Access Compliance Report Public Rights-of-Way (Curb Ramps)

Main Street: HEWES_ST Cross Street: E_SYCAMORE_AVE Location: SW

ADA ID: RPAT210929090350 Ramp Type: Type 4 - Parallel Initial Pass/Fail: Fail Overall Compliance: No Severity Score: 15

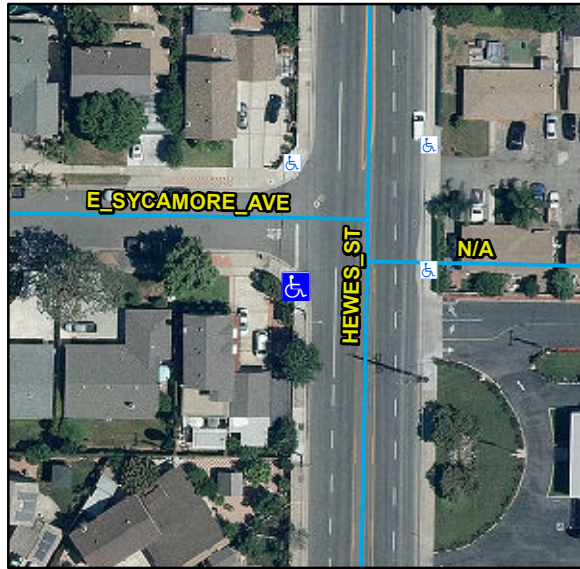
Compliance	Description	Data	Compliance	Description	Data
N/A	Ramp Length LT (in)	86	N/A	Ramp Length RT (in)	89
Yes	Ramp Width LT (in)	80	Yes	Ramp Width RT (in)	88
No	Ramp Run Slope LT (%)	12	Yes	Ramp Run Slope RT (%)	3.6
Yes	Ramp Cross Slope LT (%)	1.1	Yes	Ramp Cross Slope RT (%)	0.3
N/A	Landing Present	N/A	N/A	DWS Provided	N/A
N/A	Landing Length (in)	N/A	N/A	DWS Contrast	N/A
N/A	Landing Width (in)	N/A	N/A	DWS Length (in)	N/A
N/A	Landing Run Slope (%)	N/A	N/A	DWS Full Width	N/A
N/A	Landing Cross Slope (%)	N/A		DWS Offset Type	N/A
N/A	Landing Movement Obstructed?	N/A	N/A	DWS Offset Left (in)	N/A
	Landing Movement Type	N/A	N/A	DWS Offset Right (in)	N/A
N/A	Landing Shared	N/A			
N/A	Clear Space	Yes			
N/A	Clear Space To Crosswalk (in)	N/A			
N/A	Marked Crosswalk 1	No	N/A	Marked Crosswalk 2	No
	Crossing 1 Direction	E		Crossing 2 Direction	N
N/A	Marked Crosswalk 1 Width (in)	N/A		Marked Crosswalk 2 Width (in)	N/A

Remove & Replace Curb Ramp With Two New Directional Ramps or Equivalent.
